**Awareness of the Proximity of Vulnerable Road Users:
UN Regulation No. 46 (Devices for indirect vision)**

Proposal for Supplement 1 to the 05 Series of Amendments to UN Regulation No. 46 (Devices for indirect vision)

**Submitted by the expert from the International Organization of Motor
Vehicle Manufacturers ***

Figure (a): Traditional Outside Mirror

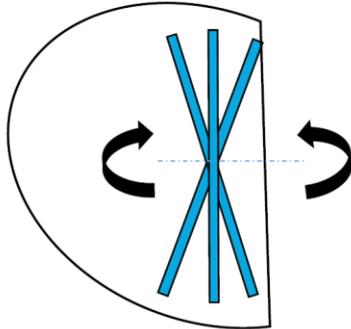
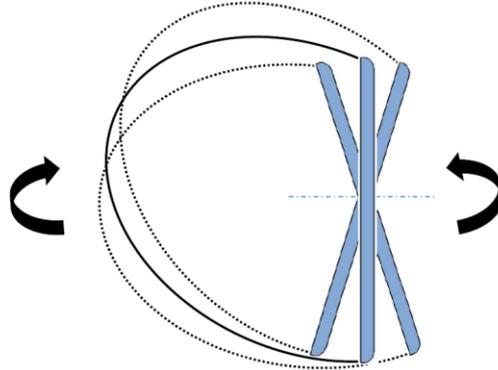
2. For Class II to VII mirrors, it is only possible to have a reflecting surface projecting beyond the housing in single adjustment positions. In this case, the reflecting surface must return into the protective housing if a force of 50 N is applied. This requirement cannot be met by mirrors where the reflecting surface is assembled onto the housing (frameless).

3. A frameless design of the mirror could reduce the width and height of the mirror significantly (up to 30 per cent). This would then have two major benefits: a reduction of collision probability with bicyclists/pedestrians and a reduction of the aerodynamic resistance (c_w).

In cases where the edge of the reflecting surface is enclosed in a protective housing (holder, etc.), the radius of curvature "c" on its perimeter shall be not less than 2.5 mm at all points and in all directions.

In cases where the edge of the reflecting surface projects beyond the protective housing independent from any adjustment position, the radius of curvature "c" shall apply to the edge of the projecting part.

In cases where ~~If~~ the reflecting surface projects beyond the protective housing **in any adjustment position**, the radius of curvature "c" on the edge of the projecting part shall be not less than 2.5 mm and the reflecting surface shall return into the protective housing under a force of 50 N applied to the point of greatest projection, relative to the protective housing, in a horizontal direction, approximately parallel to the longitudinal median plane of the vehicle.
